Application by Ørsted Hornsea Project Four Limited (“the Applicant”) for an Order granting Development Consent for the proposed Hornsea Project Four Offshore Wind Farm (“Hornsea Project Four”)

The following constitutes Natural England’s formal statutory response to the Secretary of State’s Request for Information (RFI) dated 18th May 2023. To inform this response Natural England have reviewed the following submissions from the Applicant’s 17th May 2023 response to RFI dated 5th April 2023:

Annex 1: Natural England's comments on the revised assessments for the protective provisions scenarios considered

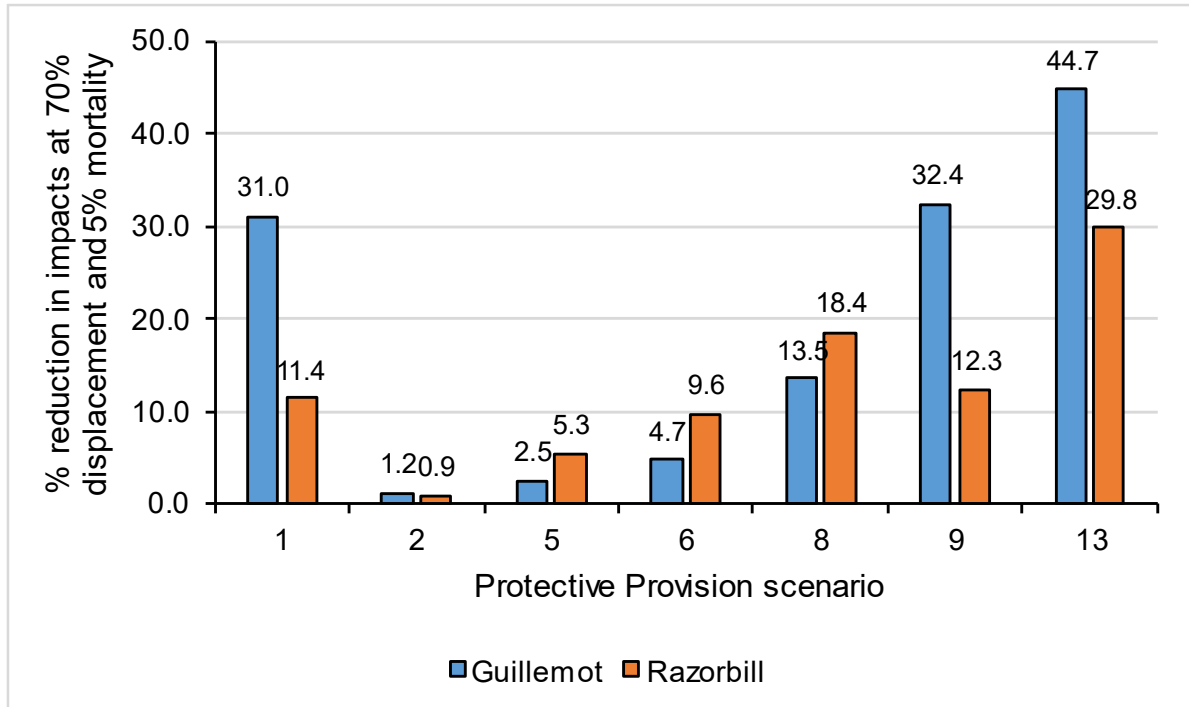
Natural England note that all protective provision scenarios result in a decrease in predicted impacts on the guillemot and razorbill features of FFC SPA relative to the end of Examination scenario, as assessed following Natural England’s guidance and 70% displacement and 5% mortality rate (Figure 1). For guillemot, the greatest predicted reductions result from Scenarios 1, 9 and 13, which equate to array area extent reductions of 117 km² (28% of array), 170 km² (44%) and 250 km² (73%) respectively. We concur with the Applicant’s view that Scenario 9 provides minimal additional benefit over Scenario 1 with respect to impact reductions, with only a further 1.4% reduction in impacts gained (15 guillemot per annum), despite it involving a much larger reduction to the array area extent (28% loss versus 44% loss). For razorbill, Scenarios 8 (121 km²; 30%) and 13 result in the greatest reductions (Figure 1). We note that whilst not assessed here, we would expect that Scenarios 10-12 would result in impact reductions between the range observed for Scenarios 9 and 13.

As well as the reduced quantitative impacts derived from the displacement matrices, Natural England also highlights that the scales of impact associated with these scenarios would also reduce (though not remove) our associated concerns about the loss of functionally-linked habitat used by auks in the chick-rearing and moult period, as this is reduced by 28-73%.
